Subject: June 2011 Inspection Report & Compliance Concerns Cameco Resources, Permits 603 & 633

PERMITS 603 & 633 INSPECTION REPORT JUNE 2011 DISTRICT 1/LAND QUALITY DIVISION

COMPANY:	Cameco Resources Incorporated
LOCATION:	North of Glenrock, Converse County (Smith-Highland Ranch Uranium Project)
DATE OF INSPECTION:	June 14 & 16, 2011
DATE OF REPORT :	July 16, 2011
INSPECTORS:	Pam Rothwell, LQD District 1 Assistant Supervisor Steve Ingle, LQD Hydrologist Julie Powell, LQD Project Engineer Robin Jones, LQD Vegetation Ecologist
CONDITIONS:	Sunny to cloudy with occasional rain showers, 50-75°, light winds (15 mph)
CO. STAFF PRESENT:	Dawn Kolkman, Cameco SHEQ Manager Dave Moody, Cameco, Wellfield Operations Manager Mike Bryson, Cameco, Wellfield Supervisor Nick Blackburn, Wellfield Supervisor Perry Herschberger, Drilling Supervisor Craig Heiser, Wellfield Development Supervisor

Figure 17c, Uncapped well in MU-H

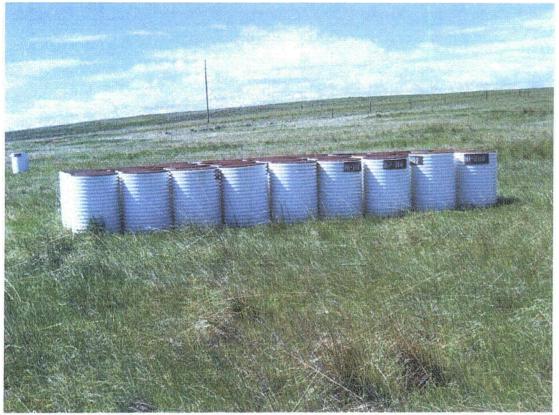
The inspectors noted wells without caps and open with standing water at depth (see *Figs. 17a, 17b and 17c*). Many of these wells did not appear to be operating. Also, the well covers for many of the wells were removed and stacked on the side of the wellfield (see *Fig 18*). Further investigation of the wellfield header houses confirmed that many wells were not in operations as indicated by the tags in the header houses (see *Figs. 19, 20 & 21*). Header houses H-1, H-2, H-3,
